LAA/AWA/19/13  
2<sup>nd</sup> April 2019

## Rotax 912i & 915i A Series Engines

### Inspection and/or Replacement of Fuel Pump Assembly

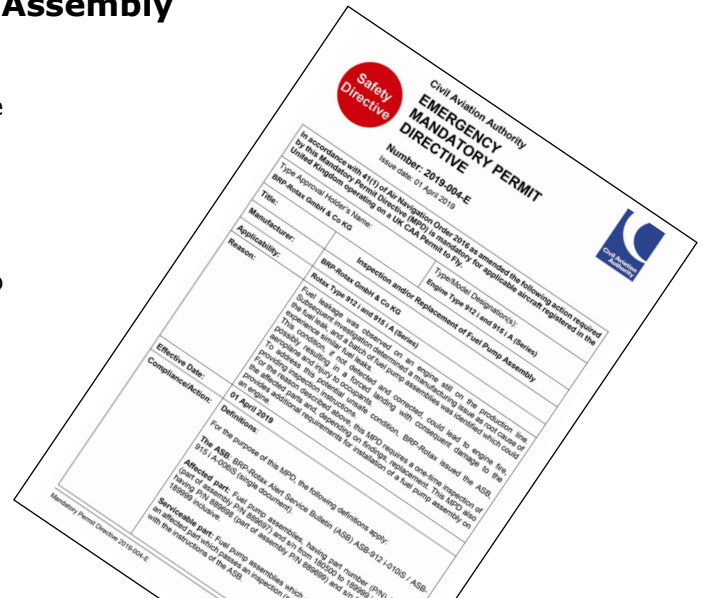
Fig.1 The Rotax 912i engine is not equipped with a mechanical fuel pump and therefore requires two high pressure rotary pumps to ensure appropriate redundancy; because of the very high flow rate, and unusually in aircraft systems, these pumps cannot be operated together. The two individual pumps are mounted in an assembly and operate in parallel. Whilst still at the manufacturer's an engine was found with a leaky pump which was later found to be caused by a manufacturing error (see 1 above for leakage point).

Fig. 2 An example of a pipe with not enough of a radius – note the reduction in the pipe's internal diameter (and therefore area).

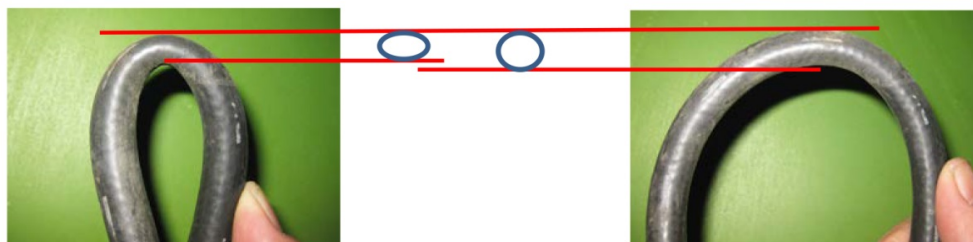
This example shows the bare minimum radius necessary to ensure no kinking in this type of rubber fuel pipe – note, different pipes will require a different minimum bend radius.
